Approved Section 4.55 (.....2.....) Modification Application

In respect to.....SSD 7484.....

SANDSTONE PRECINCT
23-39 BRIDGE STREET
SYDNEY, NSW, 2000

DEMOLITION ELEVATIONS LANDS BUILDING - SOUTH AND EDUCATION BUILDING - SOUTH

PROPOSED PLANS - EDUCATION BUILDING

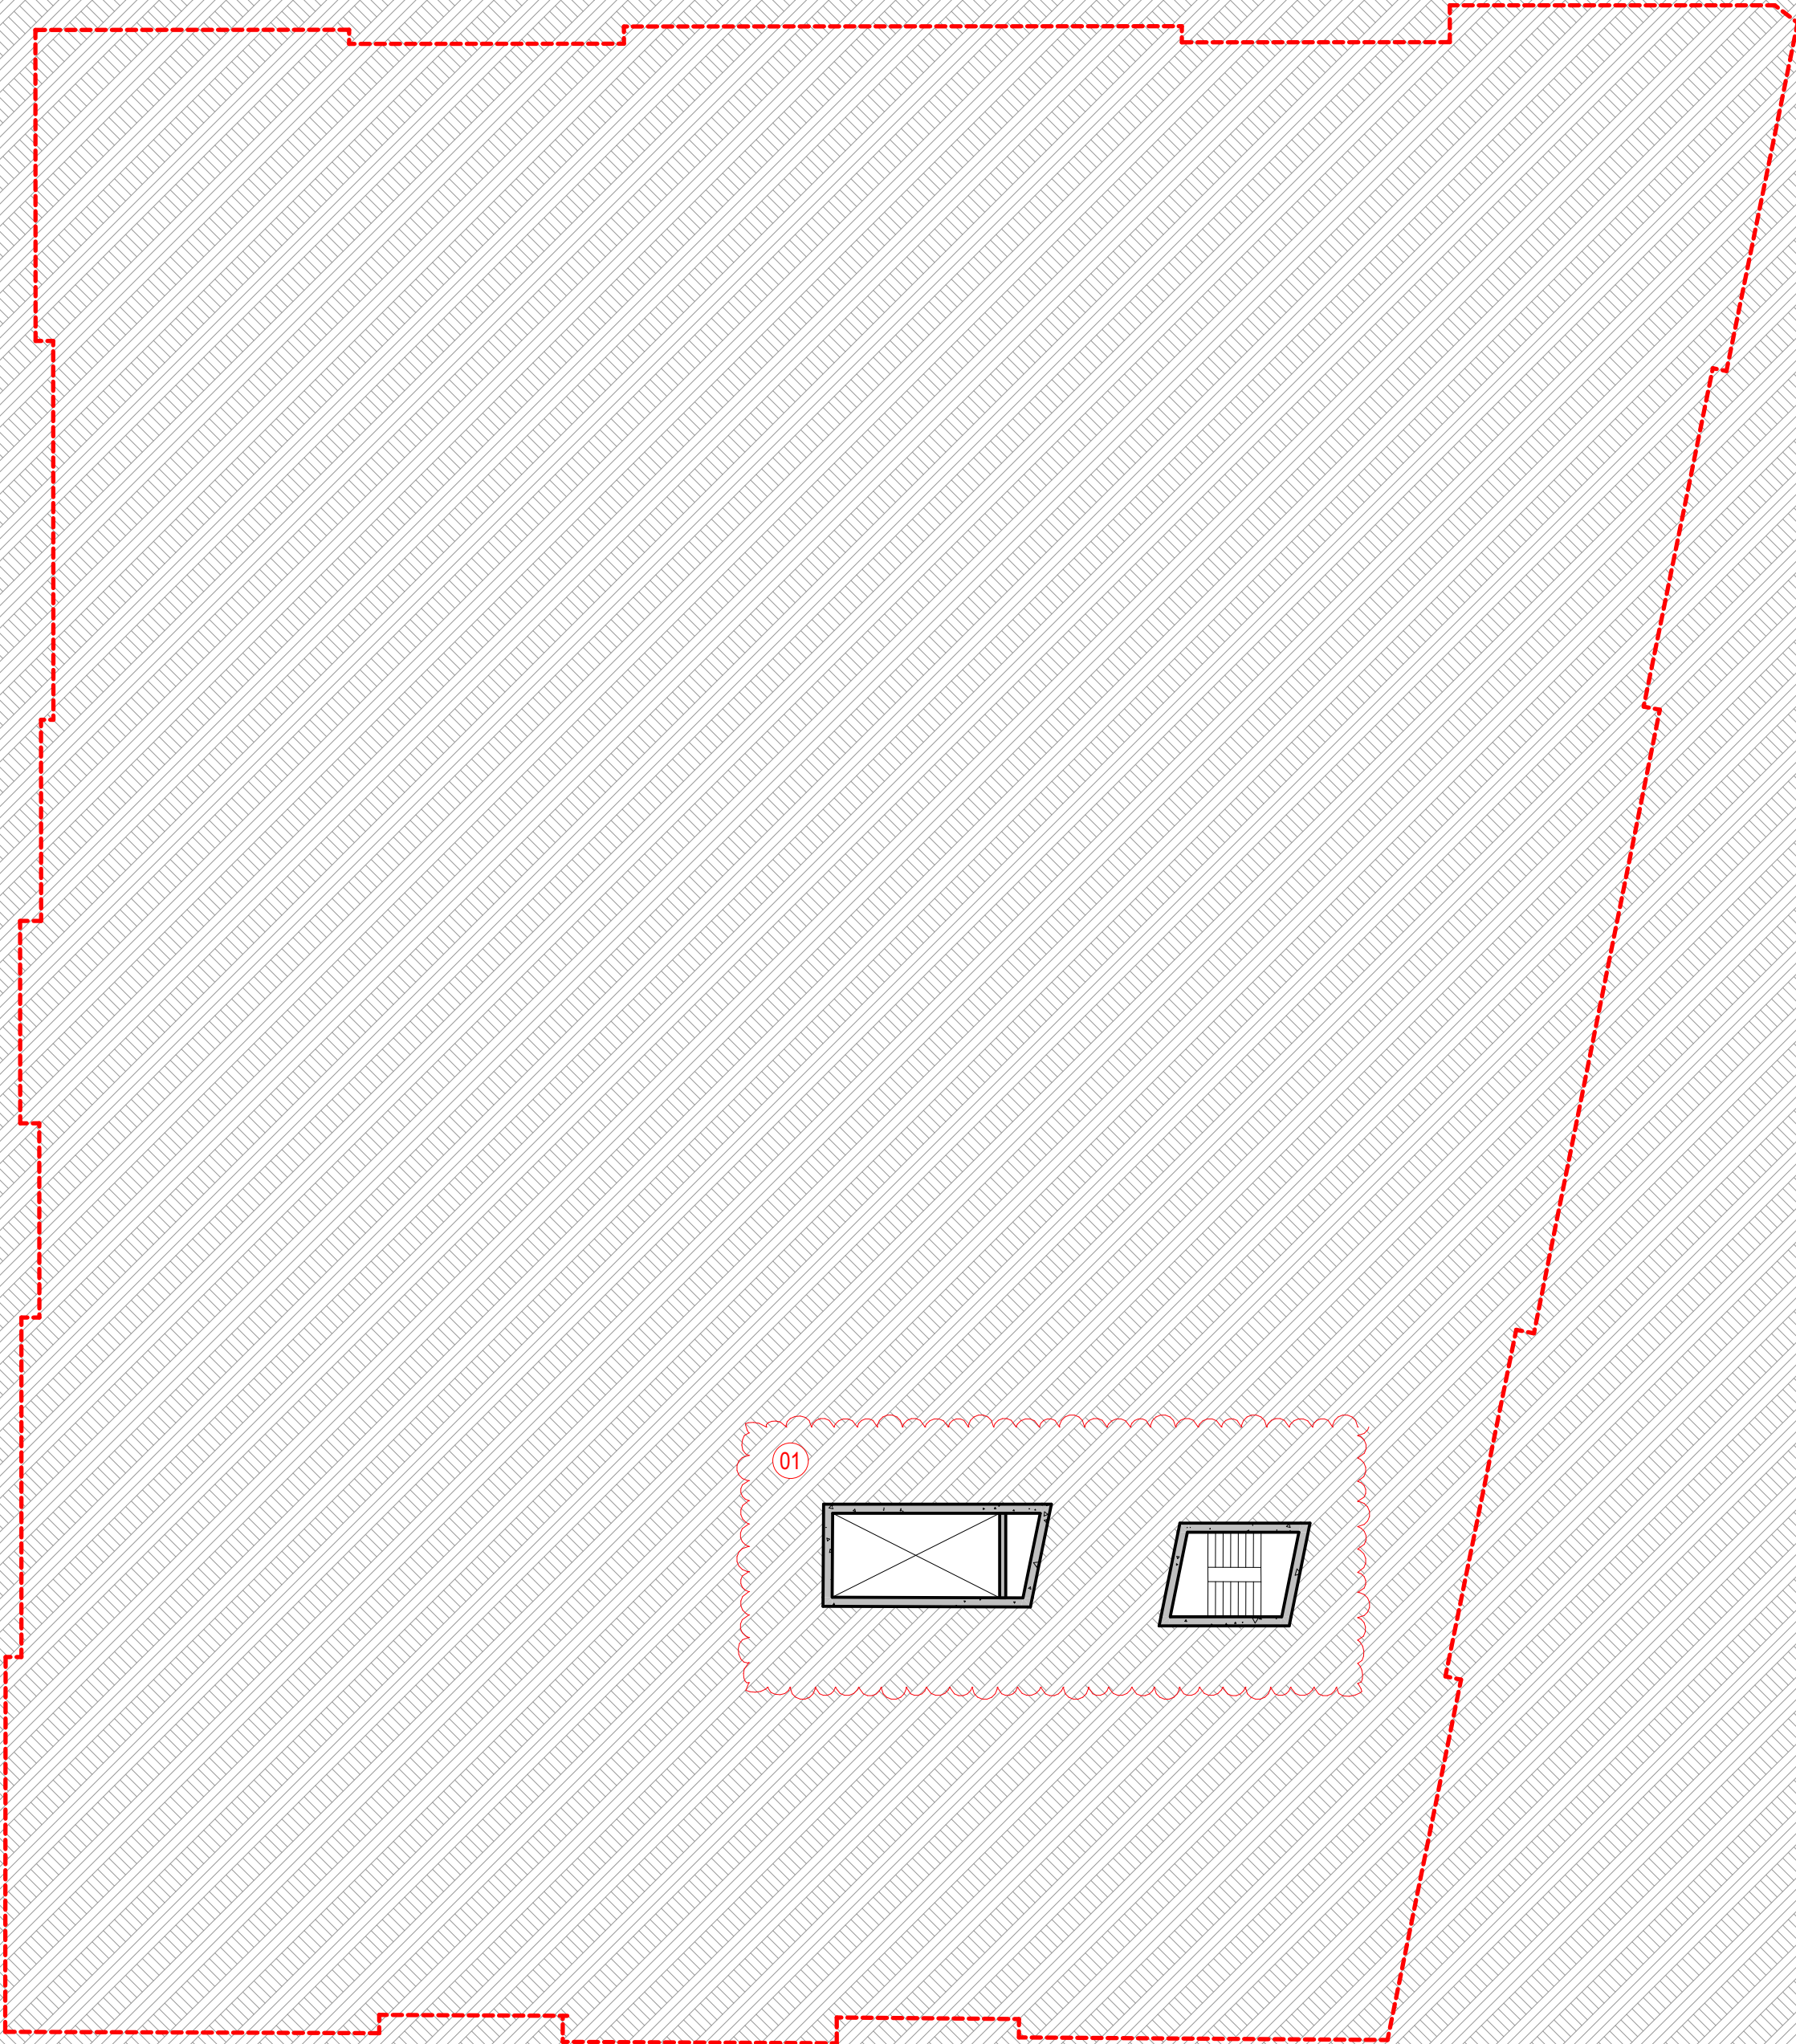
- CHANGES LEGEND:
- 01 LIFT & FIRE STAIR REDESIGNED
 - 02 REDESIGN OF STAFF DINING TO INCLUDE DISHWASHING AND COOLROOM

**PROPOSED PLANS - LANDS BUILDING -
LEVEL 02, EDUCATION BUILDING - LEVEL 01**

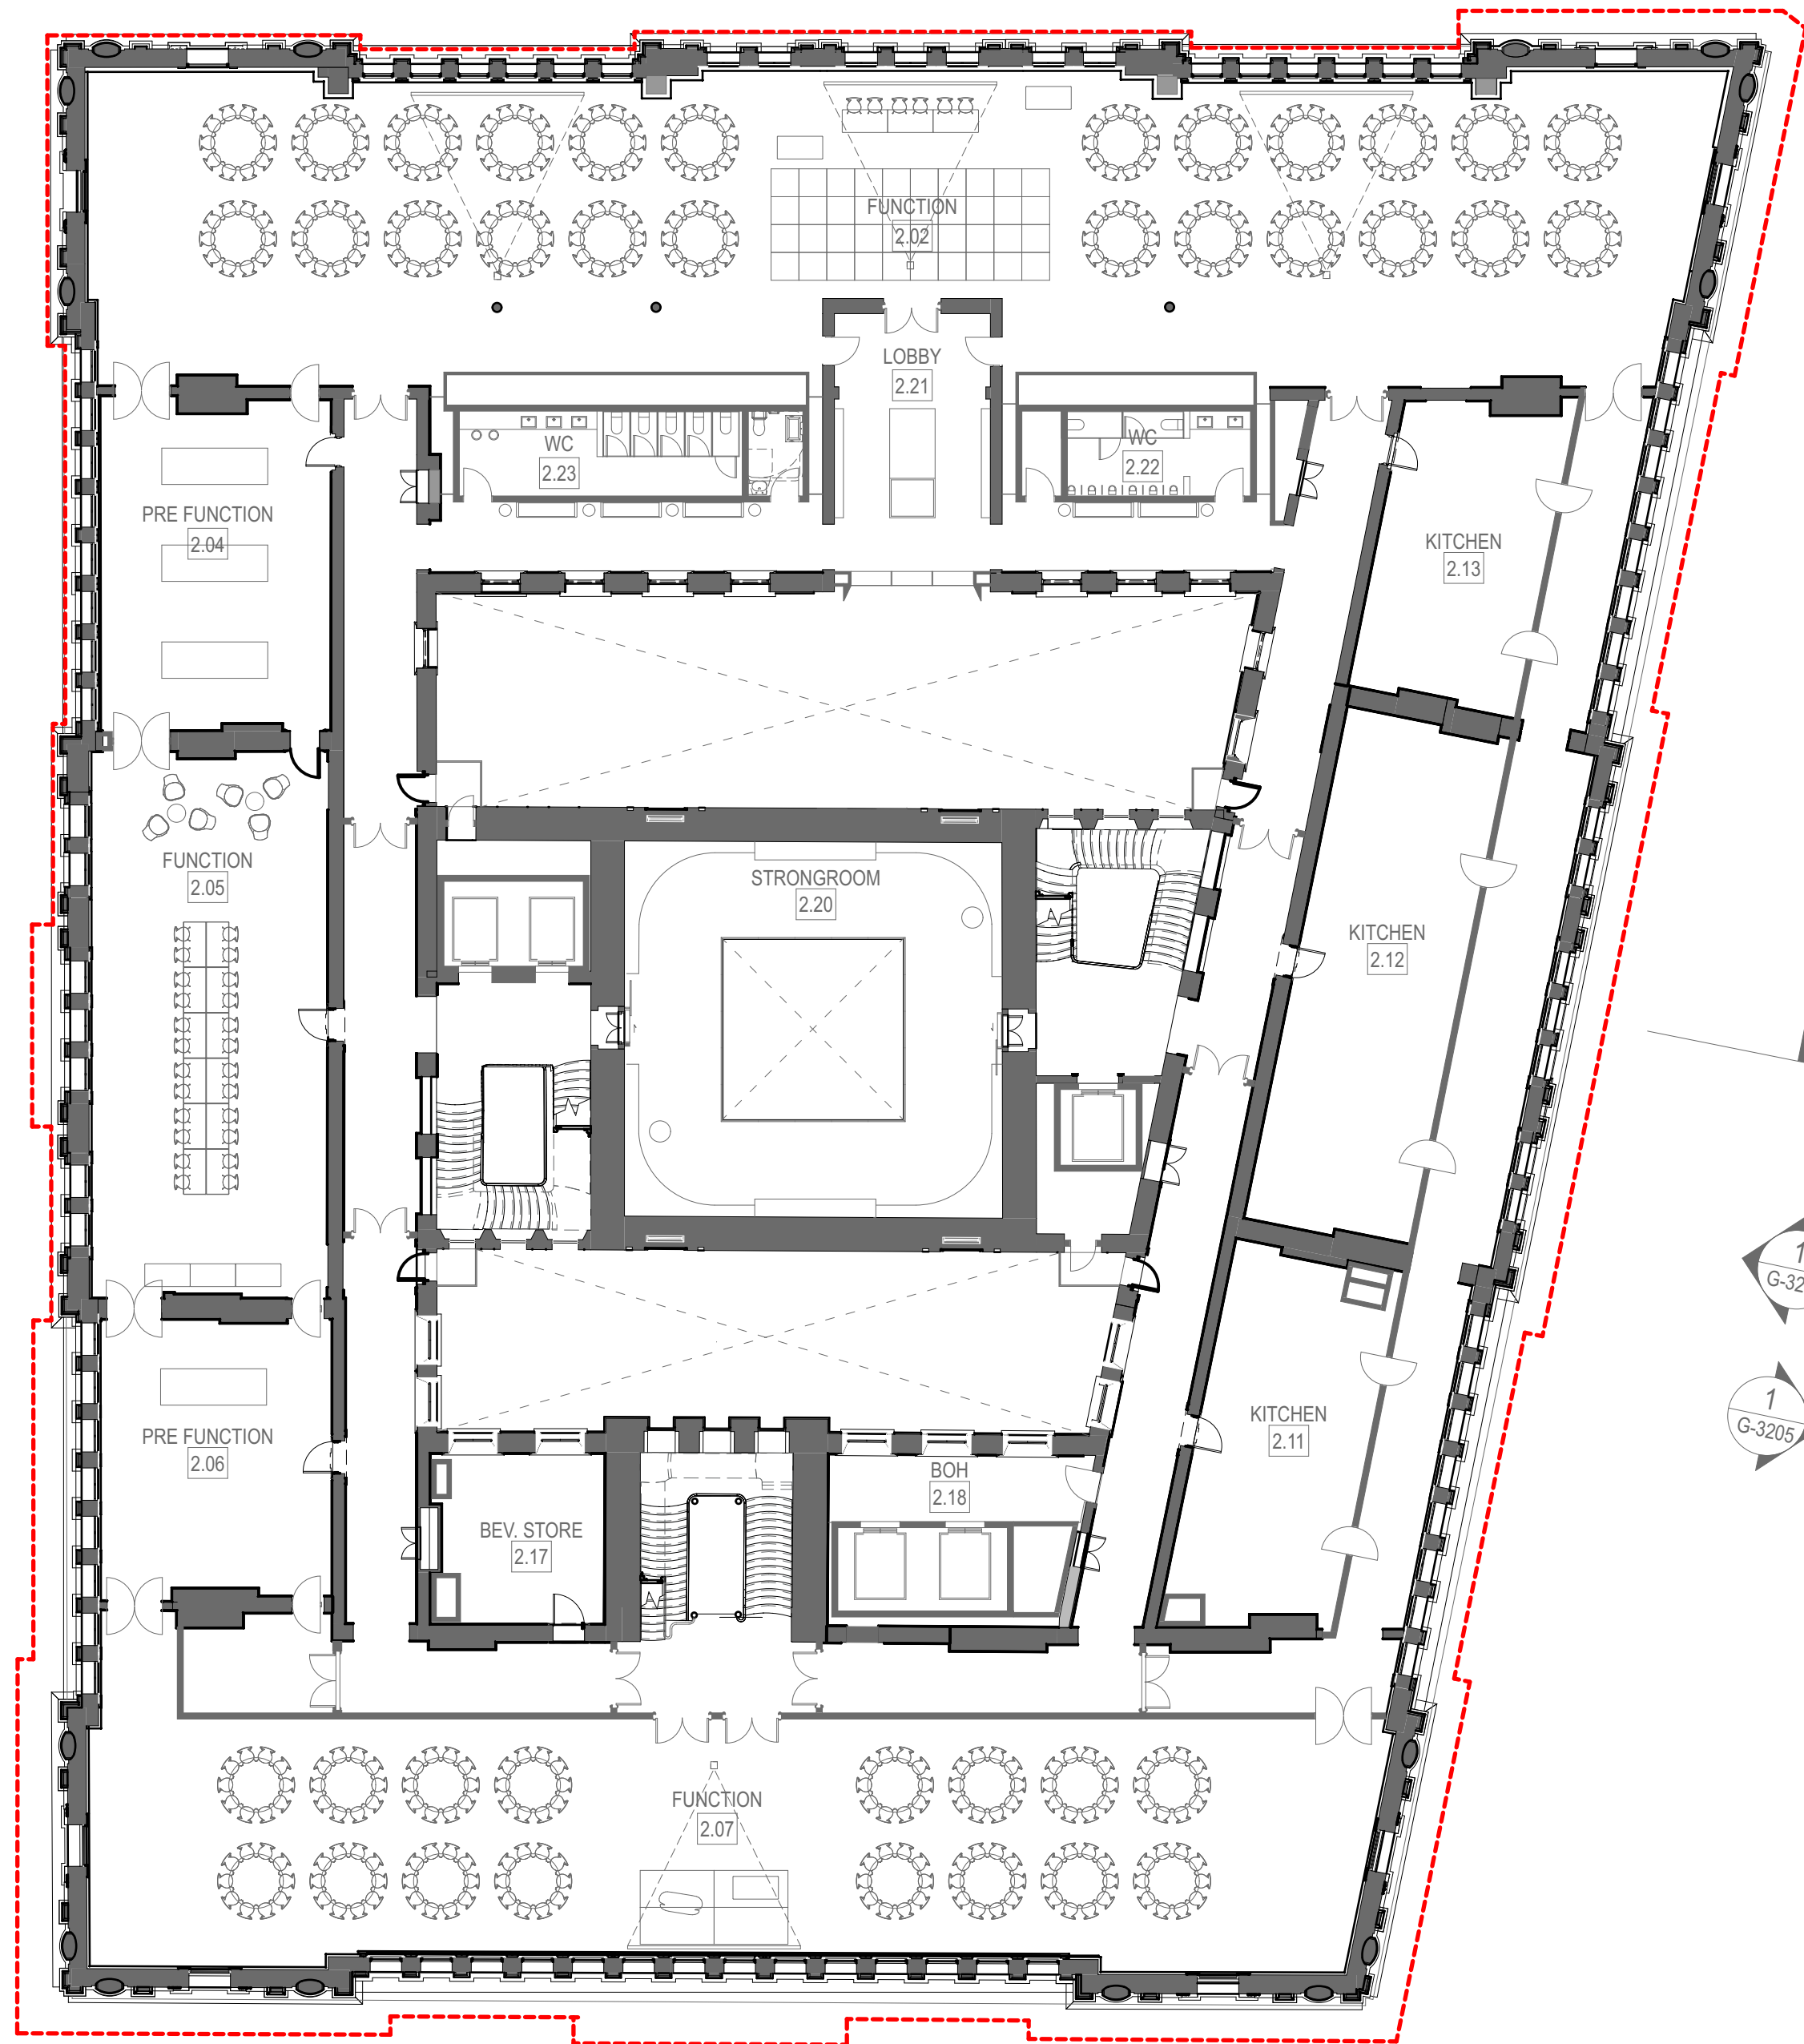
- CHANGES LEGEND:
- (01) AMALGAMATION AND RECONFIGURATION OF HOTEL ROOMS RESULTING IN A REDUCTION OF KEYS
 - (02) STAIR RECONFIGURED & HOUSE KEEPING ADDED
 - (03) DOOR RELOCATED
 - (04) WINDOW REMOVED
 - (05) NEW COLUMNS ADDED TO ACCOMMODATE REVISED POOL STRUCTURE
 - (06) LOCATION OF GREEN WALL CHANGE TO ALIGN CLADDING ABOVE

TITLE
**PROPOSED PLANS - LANDS BUILDING -
LEVEL 03, EDUCATION BUILDING - LEVEL 02**

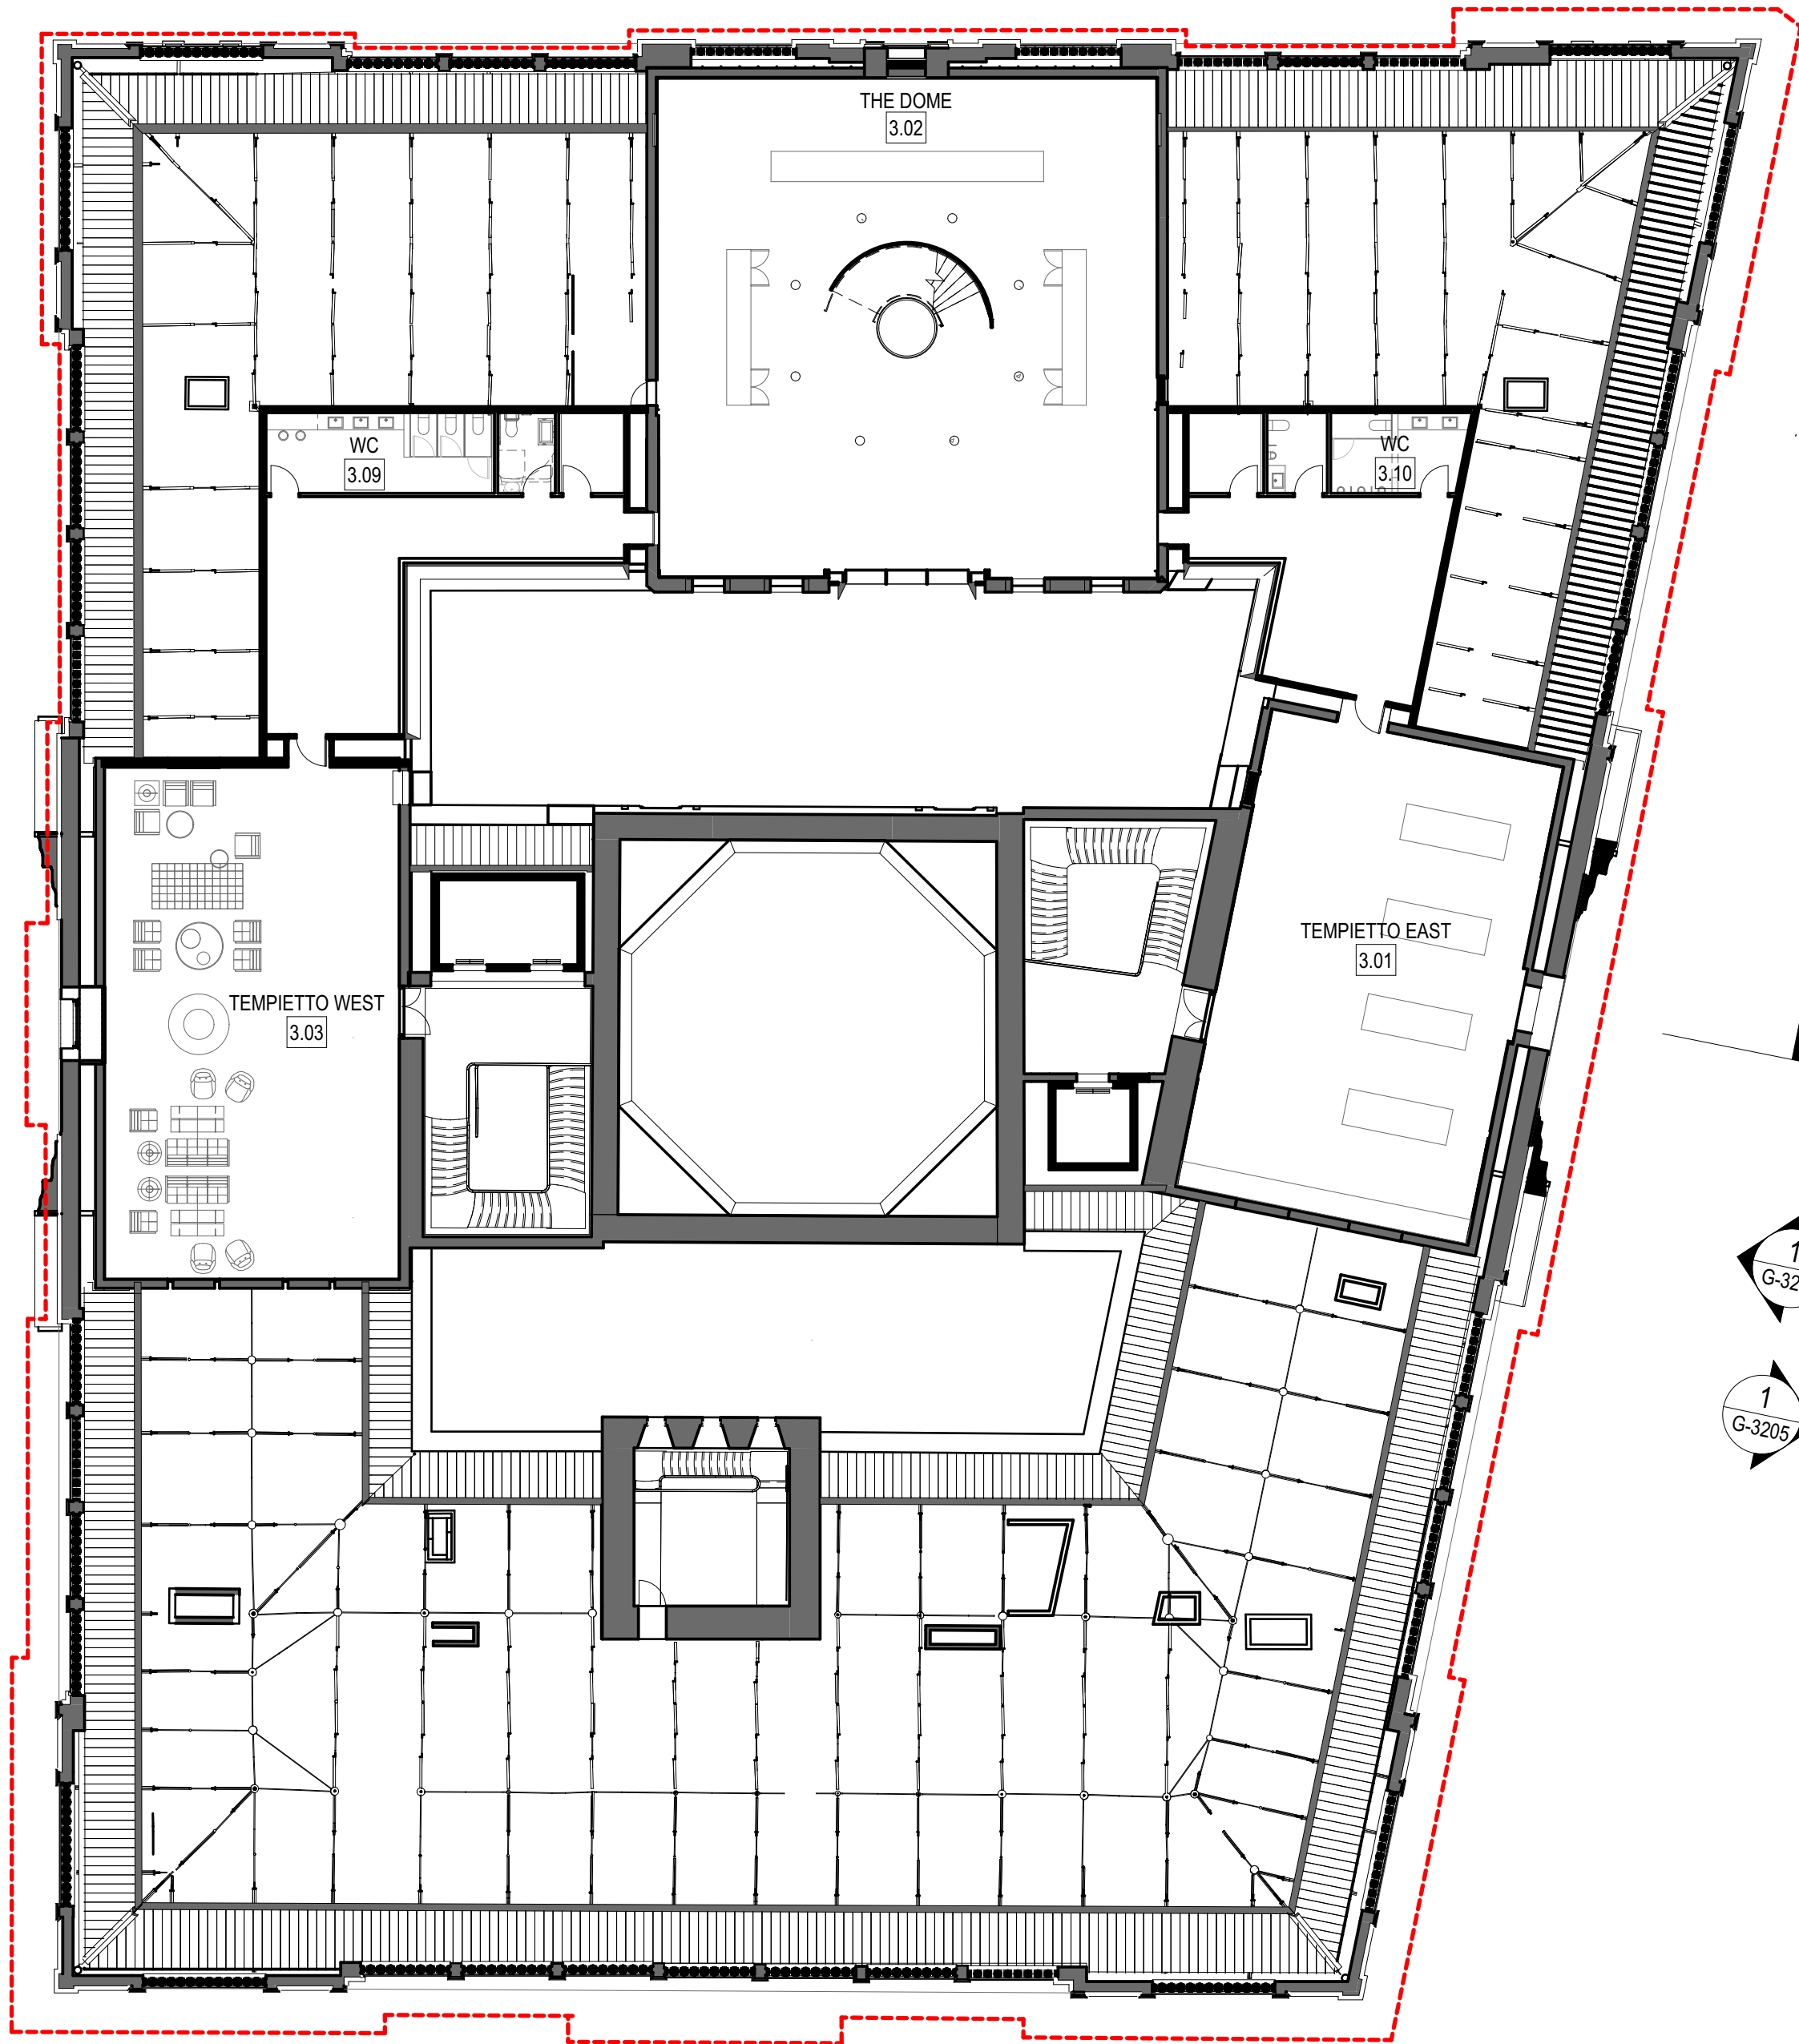
01 AMALGAMATION AND RECONFIGURATION OF HOTEL ROOMS RESULTING IN A REDUCTION OF KEYS
02 DOOR RELOCATED
03 CHANGED FLUTED FACADE TO FLAT PANEL
04 COURTYARD ROOF PANEL RECONFIGURED IN CONJUNCTION WITH COURTYARD GUEST ROOM UPDATES
05 NEW COLUMNS ADDED TO ACCOMMODATE REVISED POOL STRUCTURE
